City of Mississauga

City Department and Agency Comments

Date Finalized: 2021-06-09	File(s): A222.21 Ward: 3
To: Committee of Adjustment	
From: Committee of Adjustment Coordinator	Meeting date:2021-06-17 1:00 PM

Property Address: 4286 Greybrook Crescent

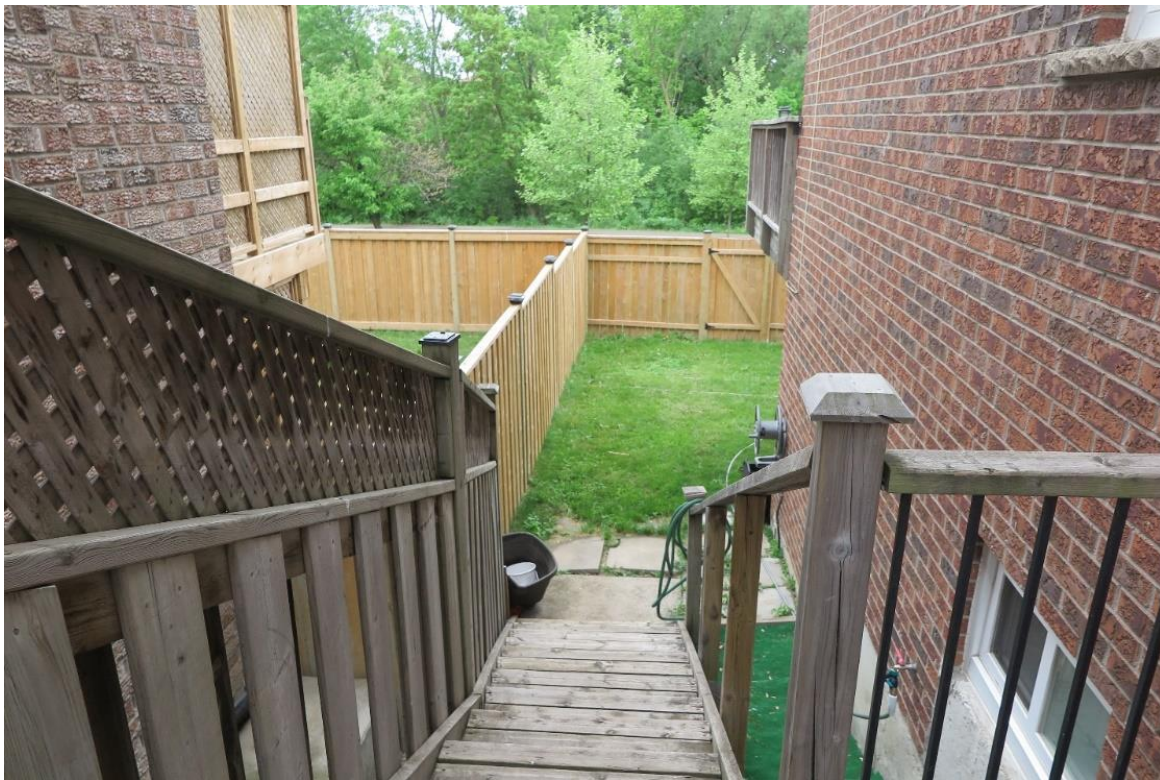
Enclosed for Committee's information are photos which depict the existing driveway and the side yard deck. Acknowledging the significant grade differential from the side yard deck to the rear yard we note that the existing drainage pattern has not been impacted.
